FLIR Radiation, Inc.
100 Midland Road
Oak Ridge, TN 37830
Tel.: (865) 220 8700 ext.101
Fax: (865) 220 7181

License Number 41-25639-01E

Dated: August 31st, 2011

Reference our license number 41-25639-01E for incorporating an exempt source into the radHUNTER product for internal calibration purposes in accordance with § 32.14 and § 30.15 (a) (9):

SIZE	DWG. NO.:	REV.
A	radHunter A2 NRC	A-04
SCALE:	ICX P/N: Various	SHEET 1 OF 2

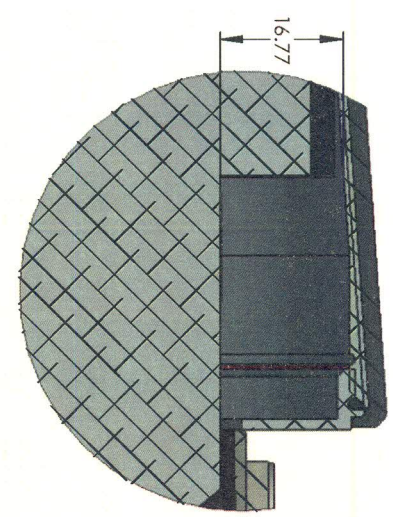
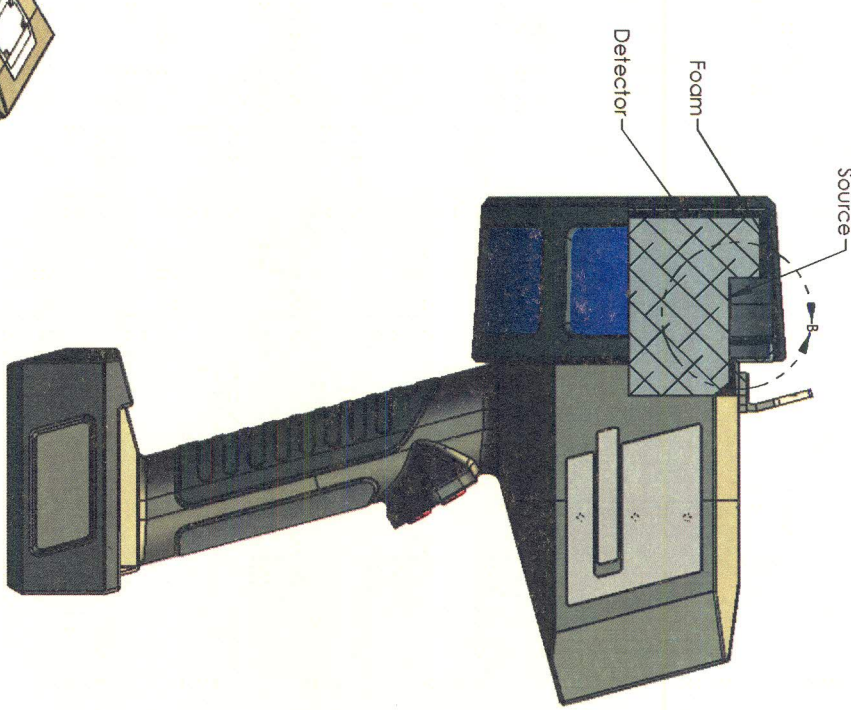
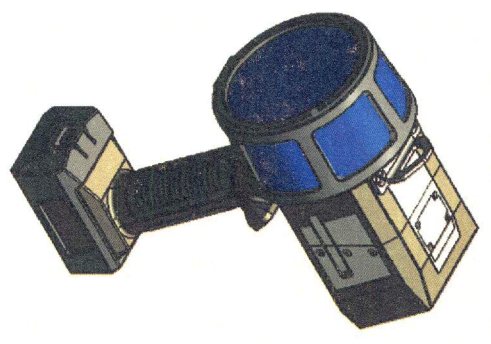
We are also requesting that the Manganese-54 or Cesium-137 sealed source be positioned on the side of the detector PMT versus the end of the detector. Due to the geometry of the detector, the measured peak energy depends greatly upon the position of the source. Changing the position of the source will greatly enhance instrument performance.

Due to the new proposed position of the source, it would also necessary to slightly increase the activity of the Cesium-137 source to 25 nanoCurie. Therefore we are requesting that the maximum activity of the exempt Cesium-137 sealed source to be used in the radHUNTER product be increased to a maximum of 25 nanoCurie.

The sealed Cesium-137 or Manganese-54 exempt source would be attached to the upper side of the detector PMT by double sided TESA 64621 adhesive tape. In addition to the double sided adhesive tape, approximately 1 ½ x 3" inches, 23-FEP clear adhesive tape would be placed over the Cesium-137 source to provide additional protection against accidental submersion of the products in water. The tape has a strong adhesive that can withstand environmental conditions beyond the products operating range. The housing is constructed from aluminum to prevent any damage to the internal components including the Cesium-137 or Manganese-54 source. Work instruction "wi-5010-radhunter-source-assembly" provides instructions on source assembly.
